**RE: MAJOR PROJECT SSD 10421
WEIGALL SPORTS COMPLEX, SYDNEY GRAMMAR SCHOOL**

This submission is written on behalf of the owners of Strata Plan 11962 at 8 Vialoux Avenue, Paddington (the **neighbouring owners**) and is in respect of the above Major Project SSD 10421 (the **Major Project**) proposing a new Weigall sports complex (the **site**) for Sydney Grammar School comprising demolition of structures, construction of three-storey and single-storey building, ancillary works involving landscaping, tree removal, kiosk substation, car parking and signage.

Figure 1 – Proposed Building 1 eastern elevation with the smaller built form of 8 Vialoux Avenue immediately adjacent (source AJ+C Architectural Drawings)

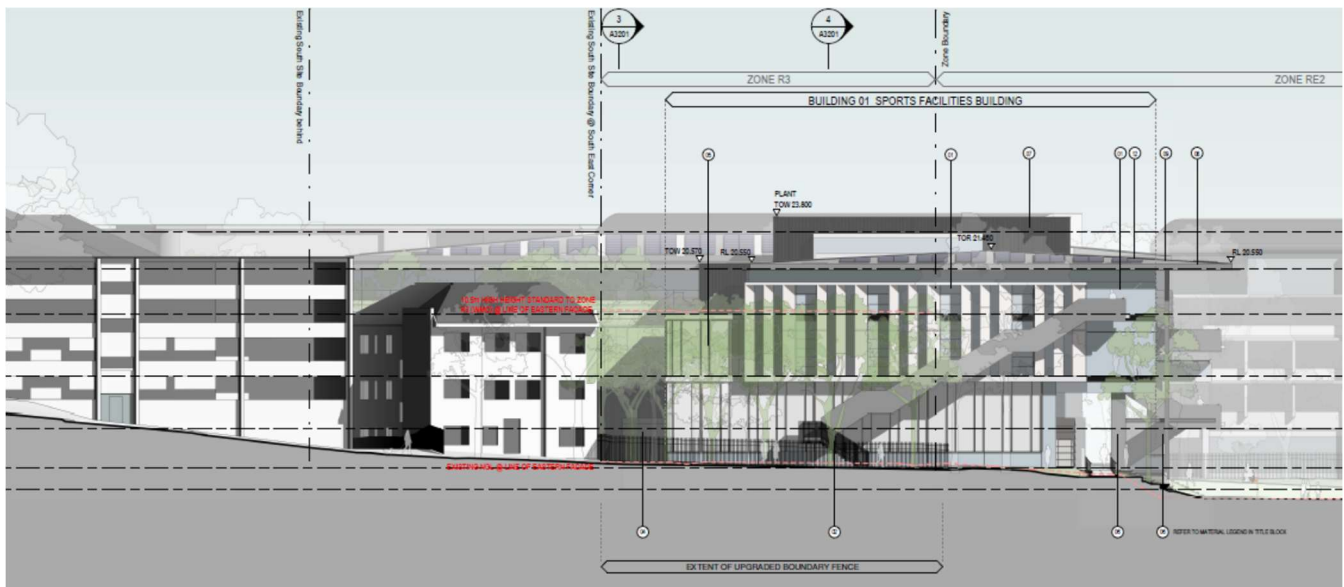
Additionally, and as demonstrated by **Figures 1 and 2** overleaf, the maximum building height for Building 1 provides for an inconsistent relationship with the neighbouring owners, directly to its south and precludes any northern outlook from the neighbouring owners.
